Access Compliance Report

Public Rights-of-Way

(Curb Ramps)

| Intersection ID: 11058 | Main Street: N_I-77_EXIT_10B_RA | Cross Street: W_5TH_ST | Location: W |

| ADA ID: 971842812F17 | Ramp Type: Para | Initial Pass/Fail: Fail | Overall Compliance: No |

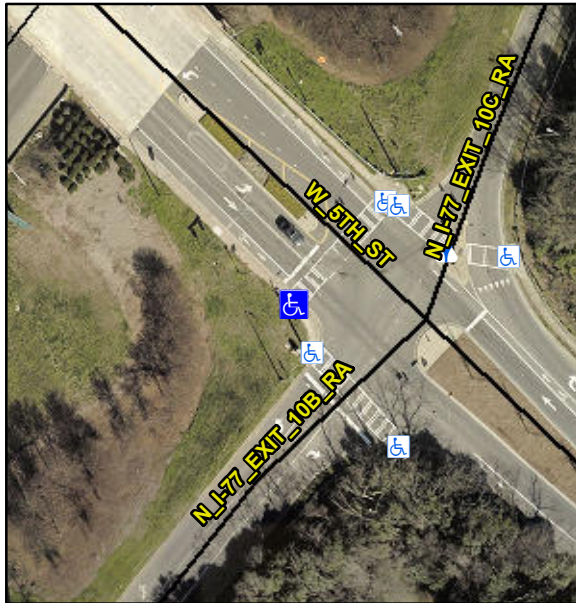
R304.5.3, R304.3.2

| Compliance | Description | Data | Compliance | Description | Data |
|------------|----------------------|-------|------------|-----------------------------|------|
| Yes | Ramp Slope LT (%) | 5.8 | No | Ramp Slope RT (%) | 8.8 |
| No | Ramp XSlope LT (%) | 2.6 | Yes | Ramp XSlope RT (%) | 1.7 |

Remove & Replace Entire Ramp.
